## RE: Bayswater's COT 30-J Pad - Form 2A Doc #401922636

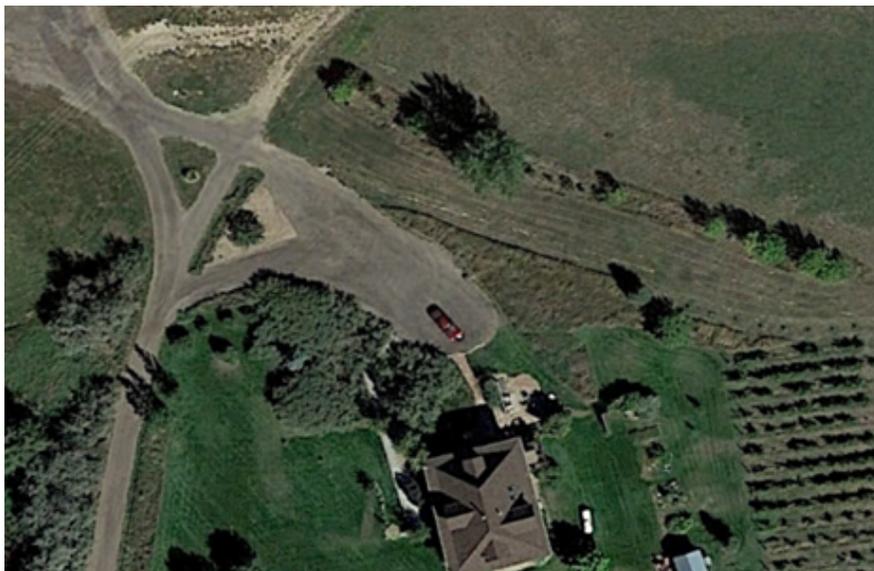
The building unit identified as within 1500' of pad disturbance to the NE is at an elevation approximately 20' higher in elevation than the pad and is mostly shielded from a direct view of the location by its existing landscaping.

The sound walls used during drilling and completion operations will also add another level of shielding of light from the location:

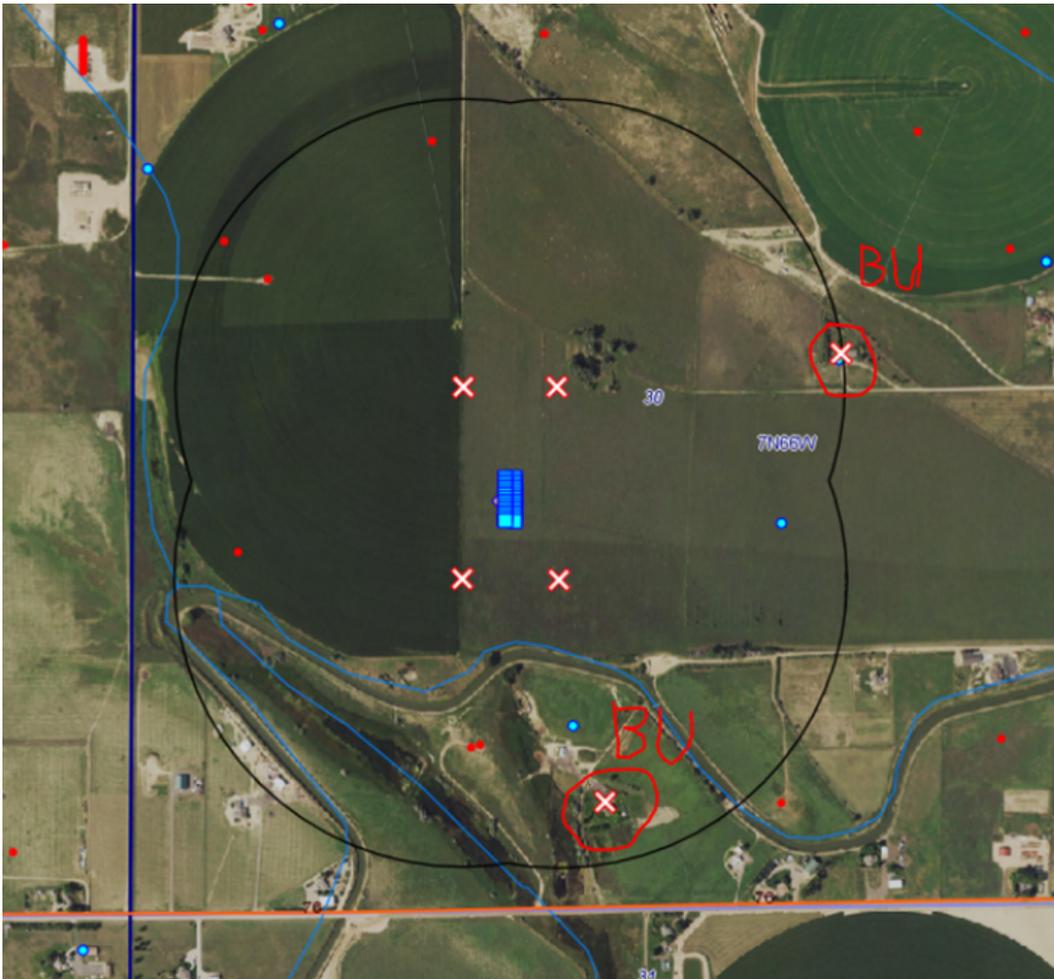
The building unit identified as within 1500' of pad disturbance to the south is approximately 25' lower in elevation and is also mostly shielded from a direct line of sight by its existing landscaping.

The sound walls used during drilling and completion operations will also add another level of shielding of light from the location:
